E-mail dated March 4, 2019

Re: 2017-489-RZ 11903/11916 Burnett Street; development information meeting Feb 28

2004 Transportation Plan (blue line in 2004 Plan is cycling network, green is pedestrian):

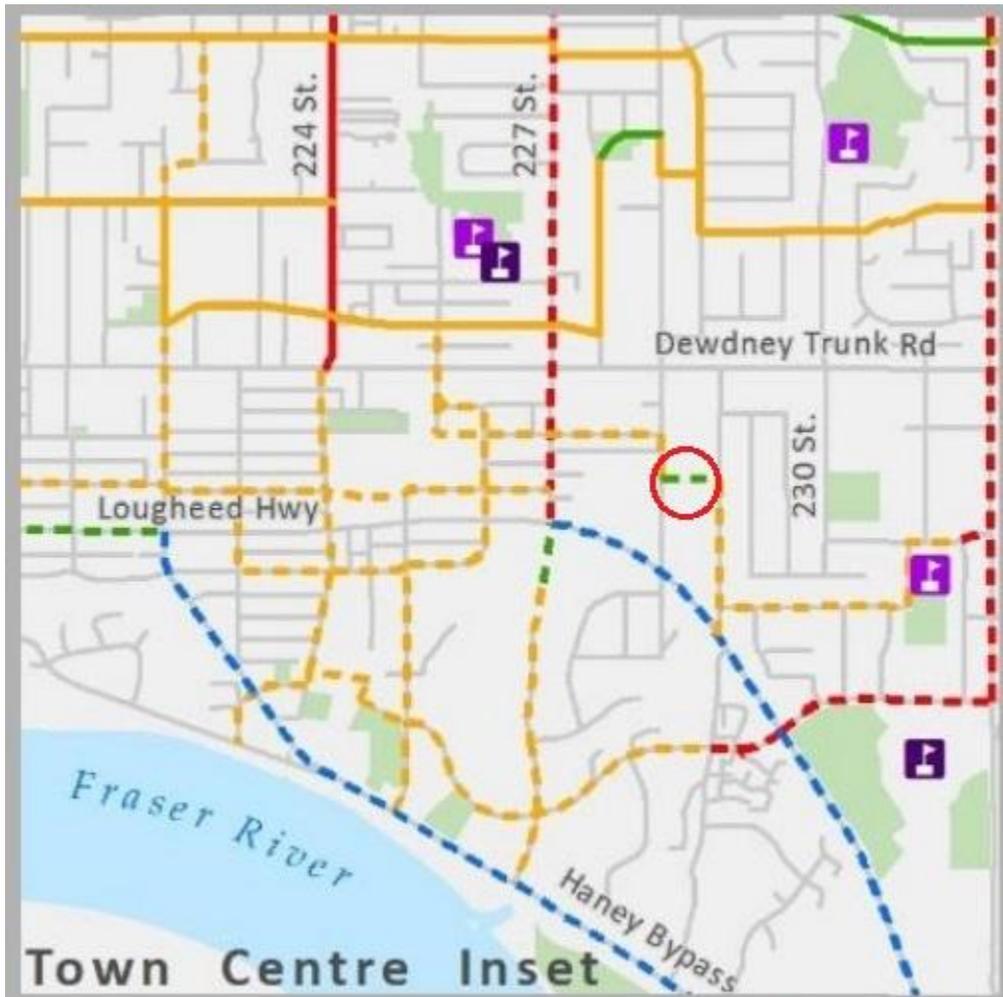
I attended the development information meeting last night for the above development for the following reason. HUB Cycling is concerned that the City apparently no longer has any intention to ensure a cycling connection is built between Burnett Street and 228th Street. However, according to both the 2004 and 2014 Transportation Plans, a cycling connection is in fact planned in this area. See below:

This pathway is a critical link in the only off-highway cycling route from a large part of east Maple Ridge into the downtown. The area served by this route stretches at least to 240 Street. If it is the City's intention to encourage transportation and recreational cycling, it doesn't make sense to create or maintain barriers along key cycling routes.

baffled gates on the Burnett side of the pedestrian pathway:

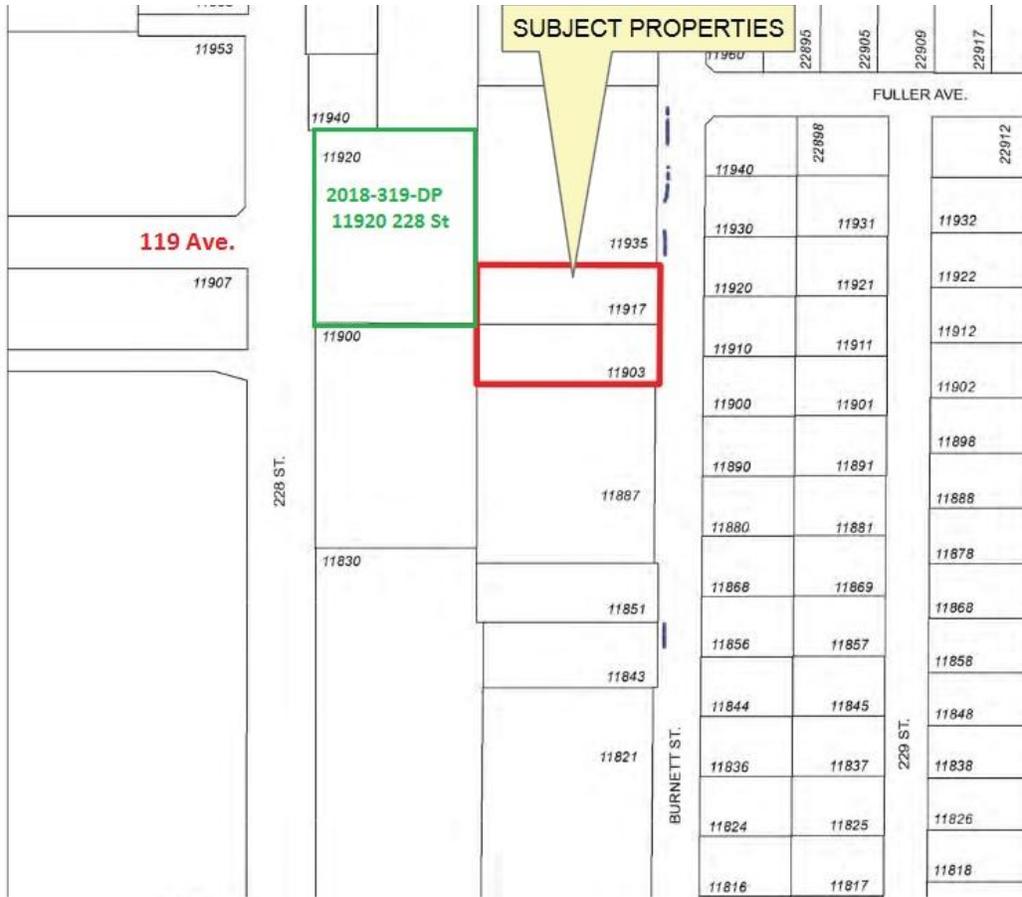
I was told by Chee Chan of the Planning Department that the existing (private) pedestrian pathway could serve also as a connecting route for people on bikes, and therefore the cycling/multi-use pathway would no longer be needed. However, due to the existing baffled gates, accessibility to this pedestrian pathway is inadequate for bikes. Those who have panniers have difficulty to pass through these baffled gates without dismounting (I'm speaking from experience), and with a bike trailer or a tricycle it will be even more difficult or perhaps impossible to use this pathway. Mr. Chan advised me that the access can not be improved, as this pathway is not a public one, but is owned by the strata development to the north. This would lead to the question whether the strata could possibly decide in future to close this pathway to the

general public altogether, which would leave no off-highway east-west link for both pedestrians and people on bikes.
